CITY OF ALBUQUERQUE

RE: **Lot 5 Block 3 Volcano Cliffs Unit 18 SAD 228**
6600 Cuervo Pl. NW
Grading and Drainage Plan
Engineers Stamp Date 1/14/2021 (D10D003S5)
Pad Certification Date 9/16/2021

Based upon the information provided in your submittal received 9/17/2021, this plan is approved for Building Permit.

ENGINEER'S SEAL DAVID SOULE P.E. #14522	LOT 5 BLK 3 U 18 VOLCANO CLIFFS 6600 CUERVO PLACE GRADING AND DRAINAGE PLAN <i>Rio Grande Engineering</i>	DRAWN BY DEM
		DATE 1-13-21
1/14/21	LOT 5 BLK 3 U 18 VC DWG	SHEET # C1
		JOB #

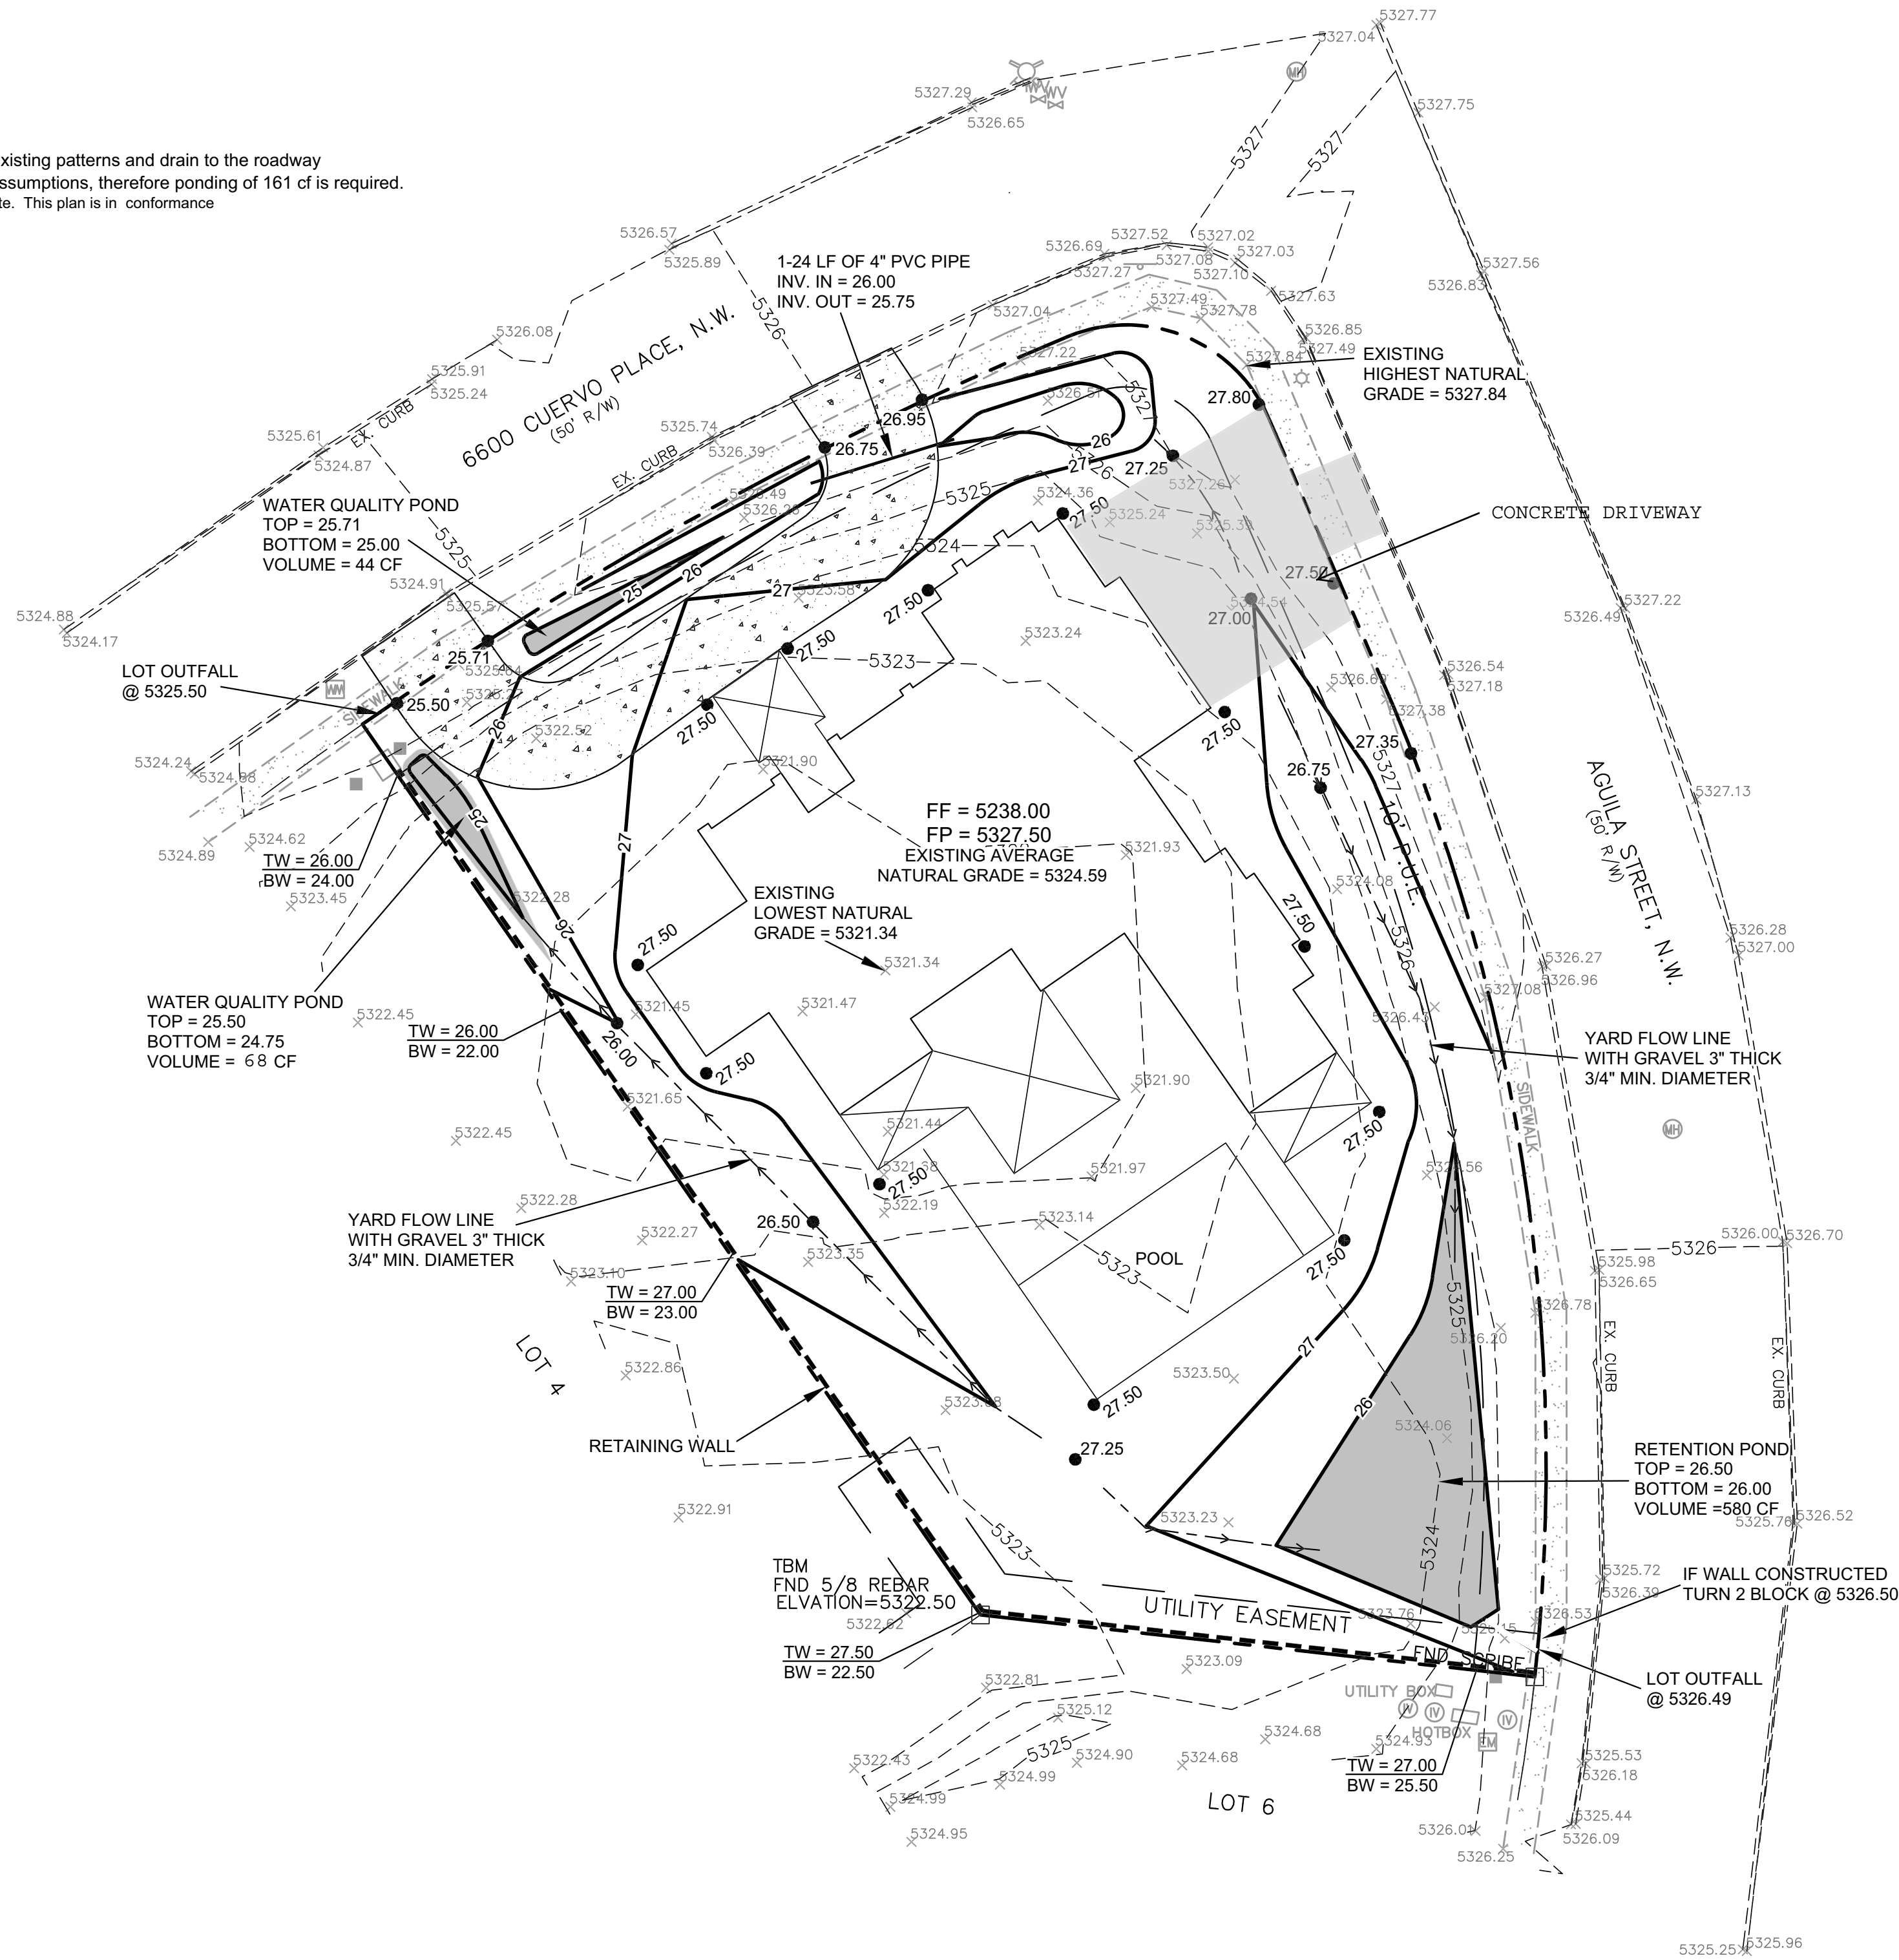
Please inform the builder/owner to attach a copy of this approved plan and this letter to the construction sets in the permitting process prior to sign-off by Hydrology. **Also, prior to CO, on the plan write a statement if the wall is built in the utility easement and wall needs to be torn down, rebuilding the wall is the owner's responsibility.**

Reiterate to the Owner/Contractor that a separate permit for a garden/retaining wall must be obtained, with the approved G&D plan and Pad Certification. Also, let the owner/contractor know that if a pool is to be added in the future the G&D plan will need to be modified showing the location of the pool and the land treatment differences. Also advise the owner & Contractor that dirt is not allowed in the public right of way to climb the curb. Crusher fines or lumber is allowed. If dirt is used this will delay going forward with the construction of the home.

Prior to Certificate of Occupancy release, Engineer Certification per the DPM checklist of this plan will be required.
